London Borough of Camden
Development Management
5 Pancras Square
London
NIC 4AG

29 July, 2018

**Comments, questions and objections to the Proposed Development at 75 Lawn Road, NW3 2XB
(Application ref: 2018/2136/P)**

Figure 1: From BIA Part 2, Figure 5, page 22 (cropped in size by us)

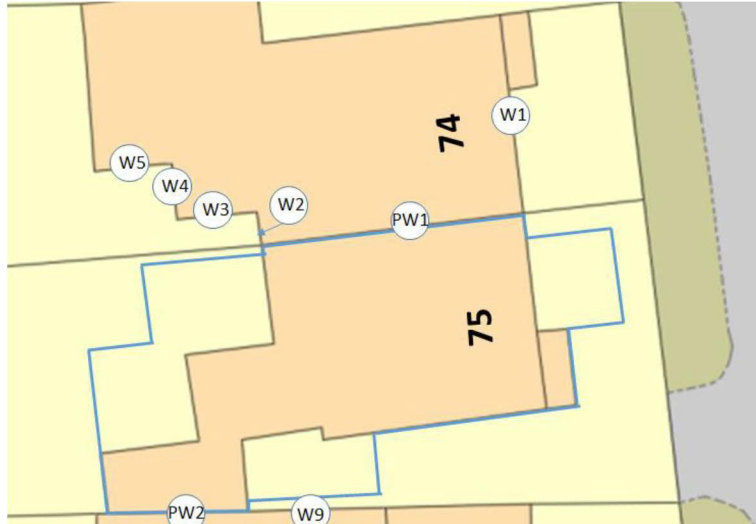
- These important calculations of the predicted damage to our house are based on an incorrect drawing (see Figure 1 above) of the back of our house and incorrect measurements.

- BIA Part 2, Figure 5, page 22 (Figure 1 above) shows W4 as an external wall. Table 4-3 says it is 2.2 metres long. This is incorrect: W4 is an internal wall that supports a steel beam that carries the whole of the weight of that part of the original back of the house, and W4 is only around 0.8 metres long, not 2.2 metres.

- BIA Part 2, Figure 5, page 22 (Figure 1 above) shows W5 as stepped back from W3. This is incorrect; it is in the same line as W3. We have a late 1970s/ early 1980s 1-storey extension across the whole of the back of our house; the original back of the house is in line with W4.

- BIA Part 2, Table 4-3, page 15 gives W2 as 1.3 metres long. This is incorrect, it is 3.6 metres.
- A whole section of our one-storey extension is missing from BIA Part 2, Figure 5, page 22 (Figure 1 above). W3 should extend to the line of the back of the house.

- Does Fairhurst know W2 is a full-width floor-to-ceiling glass window and W3 includes a large window?
